**Trinity River Channel Rehabilitation Site:
Bucktail (River Mile 105.45-107.0)
Draft Environmental Assessment/Initial Study
DOI-BLM-CA-N060-2015-0057-EA and TR-EA0215**

November 2015

**Comments and Responses on the
Draft 2013 Bucktail and Lower Junction City EA/IS**

Figure 21.A.1. Shows the TRRP contractor work area during August 14-15, 2013 high turbidity readings. Excavated areas at IC-7 were a silty sediment that clouded the water and required slowed construction to meet permit requirements under “normal” base flow conditions.

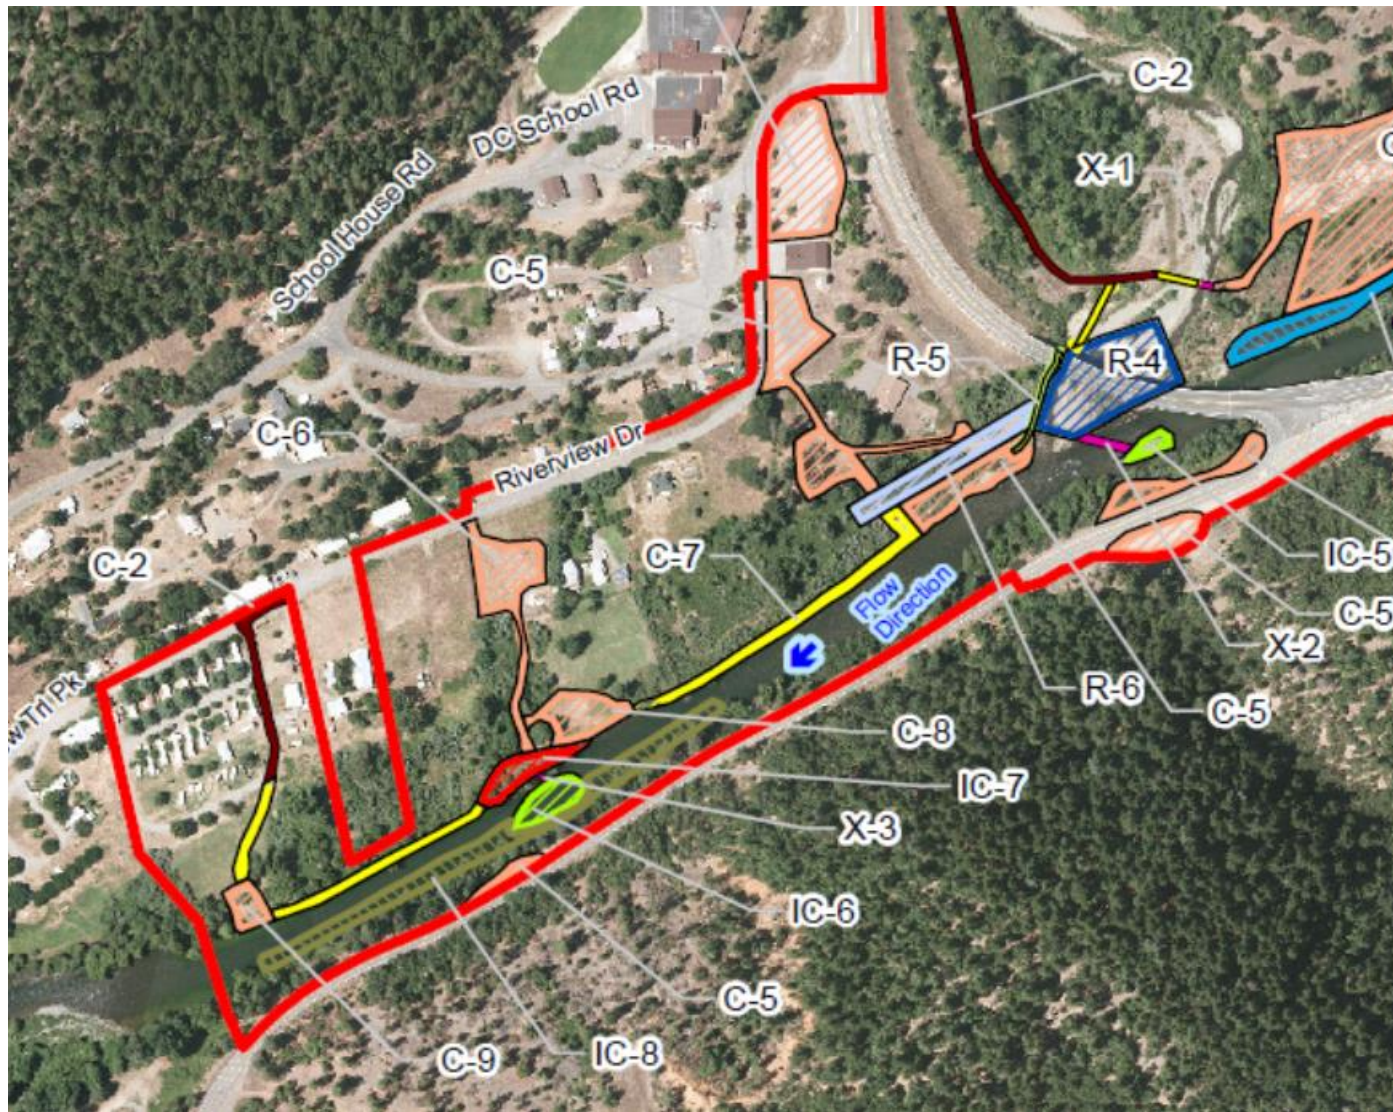
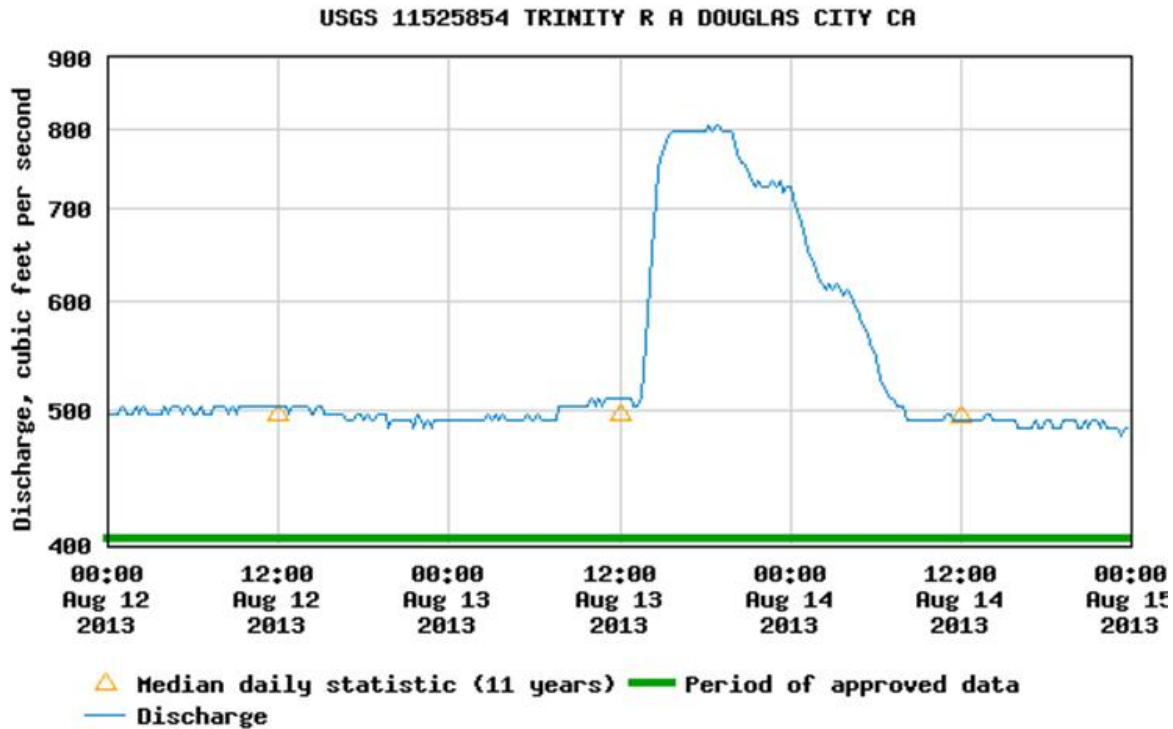
Comment 21.A. – Turbidity downstream on August 14-15, 2013.

During the August 14-15, 2013 period, the contractor was finishing construction of the in-channel meander (IC-7) and island (IC-6) downstream of the Douglas City (Highway 299 Bridge; Figure 21.A.1). The excavated material at IC-7 was the siltiest found in the entire 2013 project and required the contractor to slow excavation to stay within permit conditions. What is more, on August 13 a pulse of water between 500 and approximately 800 cfs was released from Lewiston dam for about 16 hours between 8 am and midnight. This relatively high flow release, shown in Figure 21.A.2 (at the Douglas City gauge), may have disturbed newly wetted areas the length of the river upstream of the construction site as well as at the newly excavated and silty IC-7. Both may have contributed to the overall turbid conditions seen by the commenter at that time. While Dutton Creek turbidity, stated by the commenter, was more noticeable than under “normal construction” conditions, the project activities were conducted within permit levels. Operations within these levels are considered protective of the Trinity River fishery.
